**OHIO TURNPIKE AND  
INFRASTRUCTURE COMMISSION**

**ADDENDUM NO. 1**

**PROJECT NO. 39-16-02 (PART A)  
RIGHT TWO LANES AND SHOULDER RECONSTRUCTON  
MILEPOST 186.35 TO MILEPOST 191.39  
PORTAGE COUNTY, OHIO**

**PROJECT NO. 39-16-02 (PART B)  
BRIDGE REPAIR & REHABILITATION  
OHIO TURNPIKE OVER CUYAHOGA RIVER MILEPOST 191.40  
PORTAGE COUNTY, OHIO**

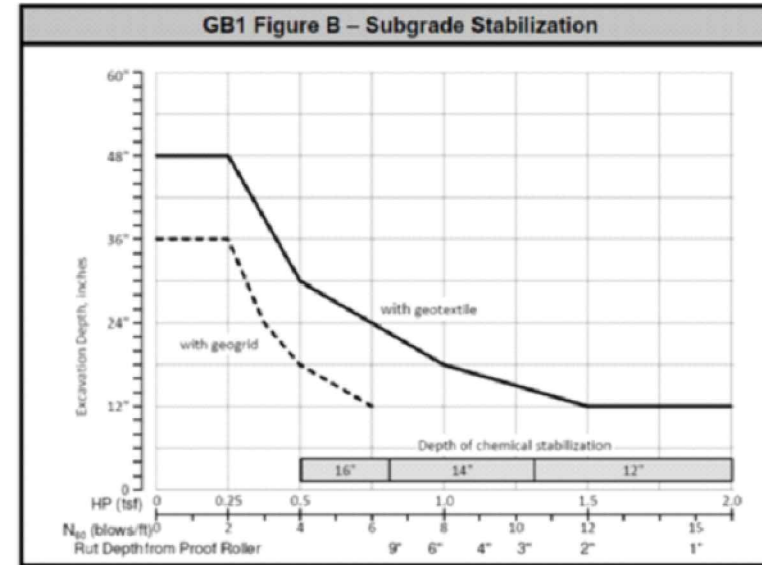
**Q#3 Could the Commission please review the quantities for undercutting and replacing subgrade soils for used as described in Section E.3, as stated on plan page 16 of 371.**

**Item 204 Excavation is 178 CY  
Item 204 Subgrade Compaction is 227 SY  
Geogrid items 204 and 861 are both 227 SY**

**Q#4 SP 304 Granular material is 6,560 tons. Is this correct? Based on the Subgrade Compaction area this material would be 43 feet thick. If this quantity is correct, could you please provide more details about the item intention?**

Plan Sheet No. 16 of 371 is modified to correct the quantity

*A#3 The above-identified quantities in the Contract Documents are correct.*

*A#4 With this Addendum No. 1, the Bid Form and Plan Sheet Nos. 16 and 188 are modified to reflect the correct SP 304 Granular Material as 360 Tons. The intent of these contingency quantities is to repair areas where subgrade stabilization using Cement was not successful based on the results of a proof roll following stabilization.*

ITEM 204 - EXCAVATION	178 CU. YD.
SP304 - GRANULAR MATERIAL	360 TON
ITEM 204 - SUBGRADE COMPACTION	227 SQ. YD.
ITEM 204 - TYPE D GEOTEXTILE, 712.09	227 SQ. YD.
ITEM 861 - GEOGRID FOR SUBGRADE STABILIZATION, AS PER PLAN, TENSAR TRIAX 160 GEOGRID	227 SQ. YD.
